LAKE PONTCHARTRAIN, LOUISIANA AND VICINITY

CONTROL STRUCTURE

PERIODIC INSPECTION REPORT NO. 3

LMVED-GS (NOD 12 Aug 83) 5th Ind
SUBJECT: Lake Pontchartrain, Louisiana and Vicinity, Chalmette Area Plan; Bayou Bienvenue Control Structure, Periodic Inspection Report No. 3, March 1983.

SETTLEMENT - LEVEES

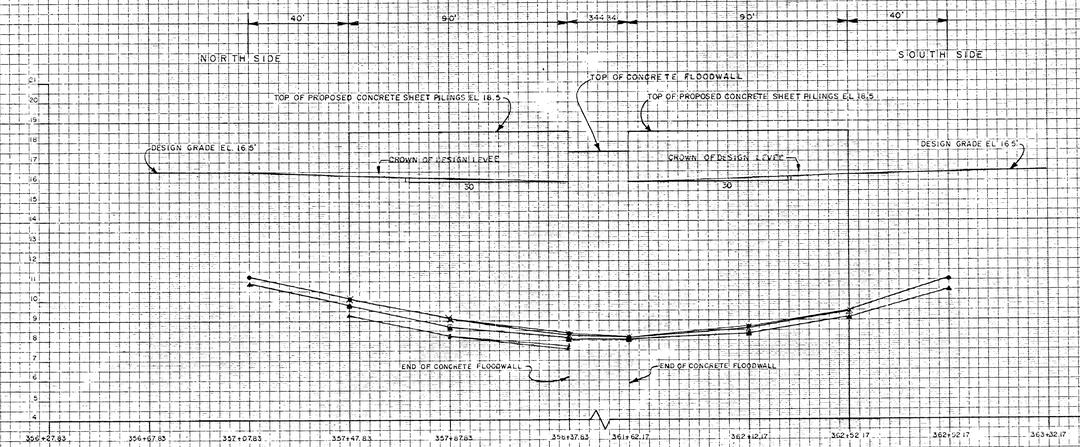
Para a. Based on telecon with your F&M Br personnel, we understand that the tie-in levee section on the southeast side of the structure was constructed in 1980 and the tie-in levee section on the northwest side is scheduled to be constructed in 1985. We further understand that the concrete I-walls on both sides of the structure will be constructed after settlement observations of the northwest tie-in levee indicate that settlement of this levee is essentially complete, i.e., in approximately 1989.

In the next periodic inspection report for this project, a subparagraph should also be included which discusses and evaluates observations of settlement of the tie-in levees on each side of the structure as shown on Plate 18. Since para 3-02 states that concrete sheet pile I-walls will be replaced when settlement of the tie-in levees has ceased, the subparagraph should include an evaluation of the time-rate of settlement of these levees. Plots of settlement versus time should be presented for a few typical settlement plates for the tie-in levees and the observed magnitude and rate of settlement should be compared with the predicted magnitude and rate of settlement to determine when consolidation of the levee and foundation is essentially completed.

a. Para 4-03. Concur. The evaluation and plots of the time rate of settlement of tie-in levees are being performed by our F&M personnel. Upon completion of the subject evaluation, the report will be revised and the information forwarded to your office.

a. Para a. The settlement analysis and evaluation discussed has been postponed until the tie-in levees at the Bayou Bienvenue Control Structure have been constructed to final grade. This work is scheduled for FY 89.

PHOTO 3: MISSING RIPRAP ALONG THE BANKS

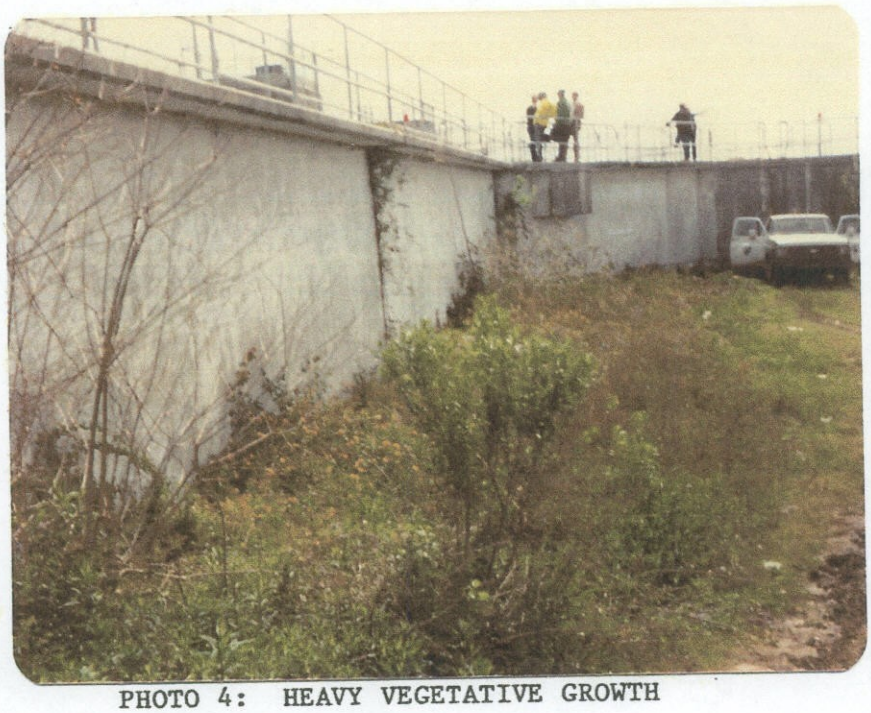
(1) Note that subpara b under Hydraulics and Hydrology on page V-4 and para 5c of the LMVD trip report in Appendix A address missing riprap along the channel banks as noted in Photo 3. Paragraph 5c of the LMVD trip report also mentions missing riprap on the outer edges of wingwalls on the Bayou Bienvenue side of the structure. Replacement of missing riprap at these locations should be addressed in para 6-02.

B. The erosion along the banks and the missing riprap revetment probably resulted from the wave action that the boats and ships generate. The missing riprap along the banks give the impression that the rocks used are lighter than needed (Photo 3).

c. Riprap was missing in many areas near the top of the channel slopes and erosion had occurred where the riprap was missing. In addition, riprap was missing from the outer edges of wingwalls on the Bayou Bienvenue side of the structure and erosion of the backfill was occurring around the outer edges of the wingwalls. It was recommended that the missing riprap be replaced along the upper channel slopes and additional riprap should be placed around the outer edges of the wingwalls to prevent further erosion.

(1) Concur. See Incl 2.
(2) Concur. See Incl 3.

* Based on experience, we find that designing this type of channel protection for a 4.0 ft wave results in a satisfactory design. The design gives the following rock gradation:

% Lighter (by weight)	Weight Range (pounds)
100	900 - 2200
50	440 - 930
15	130 - 460

This protection should have a thickness of 3.0 feet. A bedding of 1.0 ft of shell under the rock is recommended.

c. Replacement of missing riprap along the channel banks and on the outer edge of wingwalls.
